Subject: Redesigned Input Shaft Sensor for Hybrid Transmissions

Document Number: TAIB0847 EN-US

Date: October 7, 2013

Service Bulletin – Product

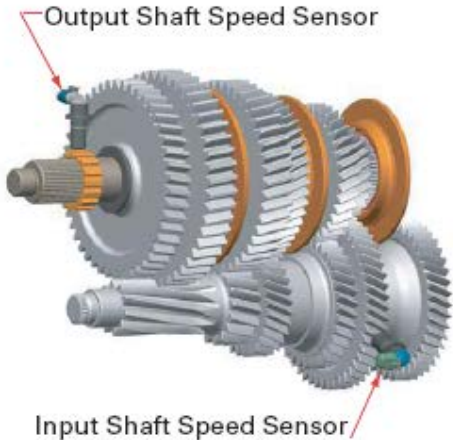
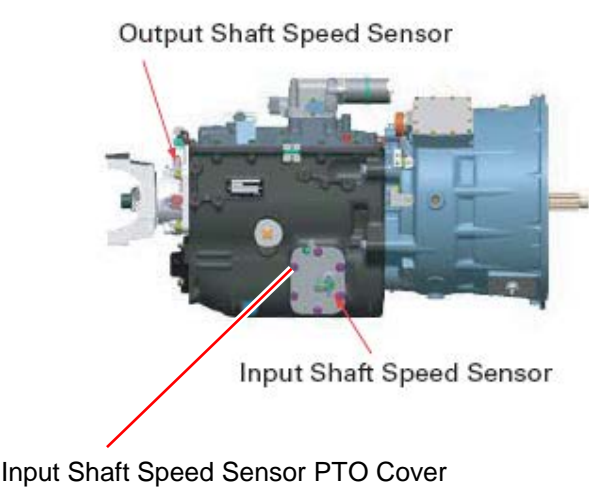
A redesigned speed sensor has been released into production and service. External changes include a sensor body designed to minimize corrosion seizing and integrated retaining clip that will not distort the sensor when the retaining capscrew is tightened. Sensor output signal, harness connector interface and 14142 O-ring are all interchangeable with current design sensors.

New Sensor 4307349

Old Sensor 691905

For drive socket clearance during installation, a new external Torx head retaining screw will also be included in the sensor service kits that use the integrated retaining clip.

- Replaces X-8C-409 (0.250" - 20 x 0.625")
- Use E8 external Torx drive socket for installation
- Torque spec is 4-6 lbs. ft. (6-8 Nm)

4305936 Old PTO Cover Speed Sensor Sealing Area

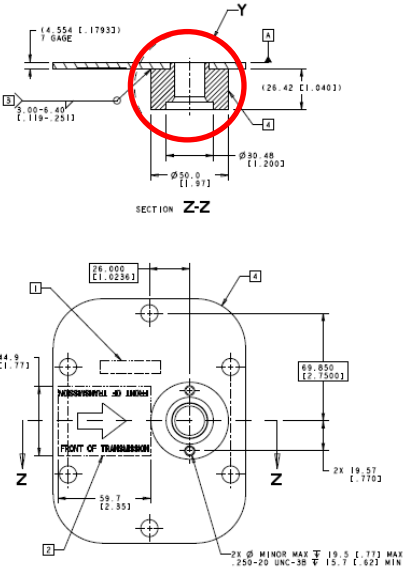
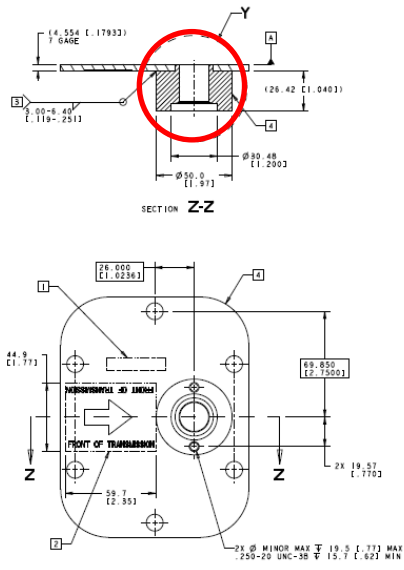
A speed sensor design was changed March 2013. The sealing O-ring was **moved up** on the speed sensor.

If the current design speed sensor is changed to the new design the **PTO cover must be changed** to accommodate the new sealing O-ring location of the speed sensor.

All Hybrid transmissions produced to date use the 4305936 PTO cover and 691905 speed sensor. A Hybrid transmission serial number and cut-in date will be added to this FSUD once 4308332 PTO cover and 4307349 speed sensor are in production. 4305936 PTO cover and 4307349 speed cannot be used together possibly resulting in a low lube failure.

Replace the PTO cover if the new 4308332 sensor is replaced. Instructions from K-4211 (L-2013-15) will be changed in K-3772. K-3772 will continue to be used as the service kit for the output shaft speed sensor. InfoRanger will be updated to include K-4211 to service the input shaft speed sensor.
